**FAQ Number:** 09-0056

**FAQ Title:** Radioactive Release Transition

**Submitter Contact:** NRC (Charles Moulton)

NEI 04-02, Section 4.3.4 and Appendix G

Figure 4.3.4.1

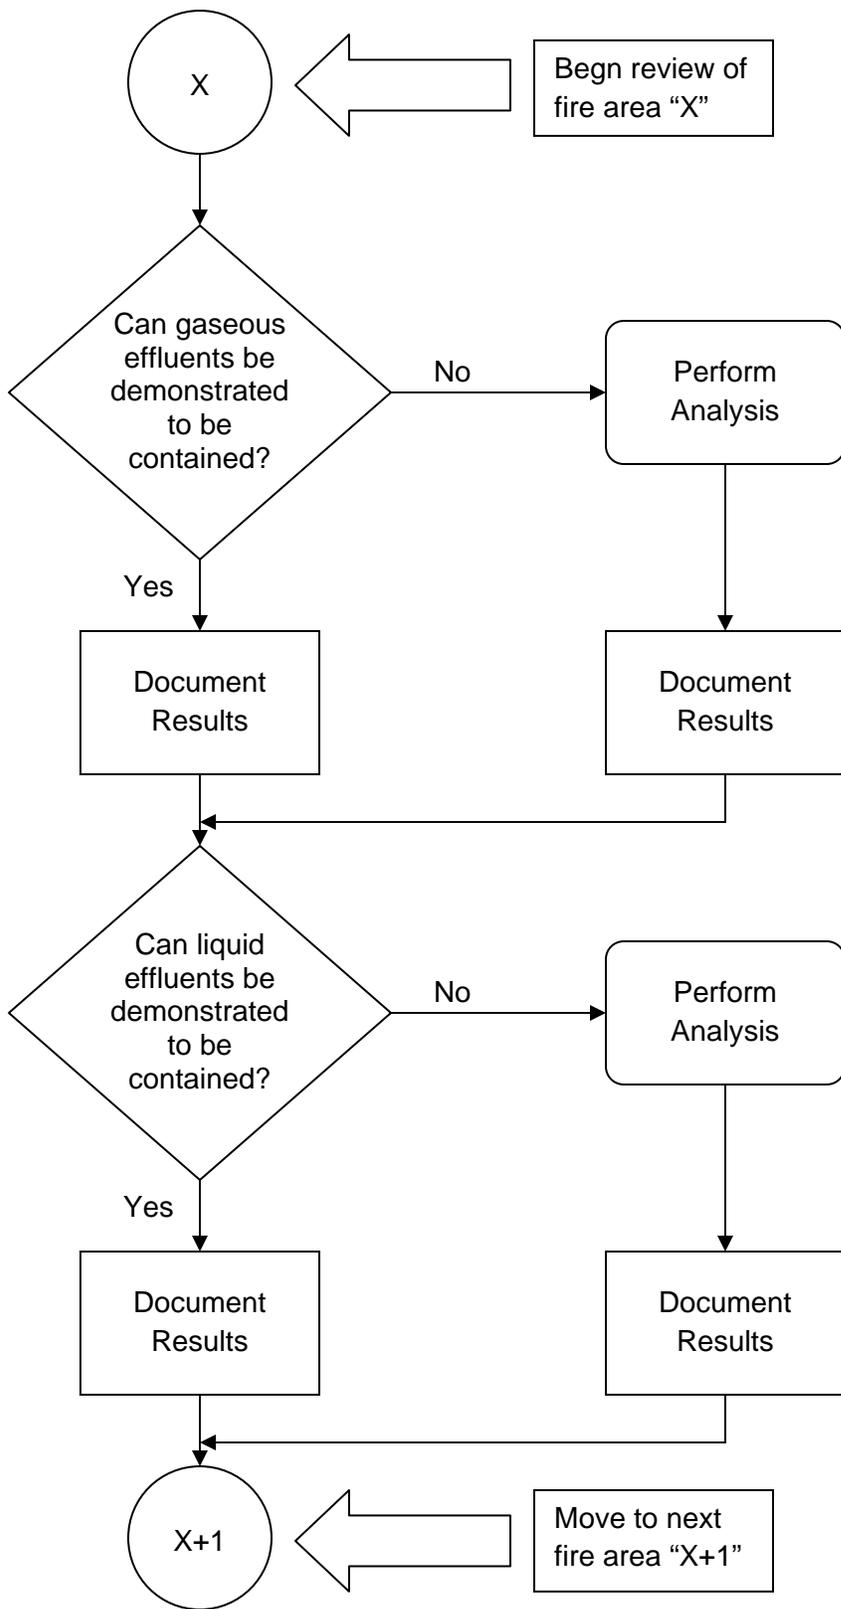
The information provided in the pilot LARs describes review of the fire pre-plans and fire brigade training to address potential effluent (water run-off and smoke) release during a fire per the NEI 04-02 guidance. However, neither LAR specifically addressed the NFPA 805 radioactive release goals, objectives, and performance criteria, nor did they provide an assessment of whether and how the FPP will meet the criteria.

Revise NEI 04-02 Section 4.3.4 and Appendix G to clearly identify the information needed to demonstrate compliance with the radioactive release goals, objectives, and performance criteria, including:

Furthermore, methods for achieving radioactive release performance criteria must be addressed on a fire area-by-fire area basis (NFPA 805 Section 2.2.4). However, with proper justification, this criterion may be met on a finer or coarser level, such as fire zone or grouping fire areas together if the same measures, systems, and procedural controls apply. Additionally, the review for radioactive release must cover all plant operational modes, including full power and non-power modes.

To demonstrate compliance with the radioactive release goals, objectives, and performance criteria, the following strategy is recommended:

- Review fire pre-plans and fire brigade training materials to identify FPP elements (e.g., systems / components / procedural control actions / flow paths, etc.) that are being credited to meet the radioactive release goals, objectives, and performance criteria during all plant operating modes, including full power and non-power conditions.
- Review engineering controls for to ensure containment of gaseous and liquid effluents (e.g., smoke and fire fighting agents). This review shall cover all plant operating modes (including full power and non-power conditions). Otherwise, provide a bounding analysis, quantitative analysis, or other analysis that demonstrates that the limitations for instantaneous release of radioactive effluents specified in the unit's Technical Specifications are met. (See Figure 4.3.4.1)
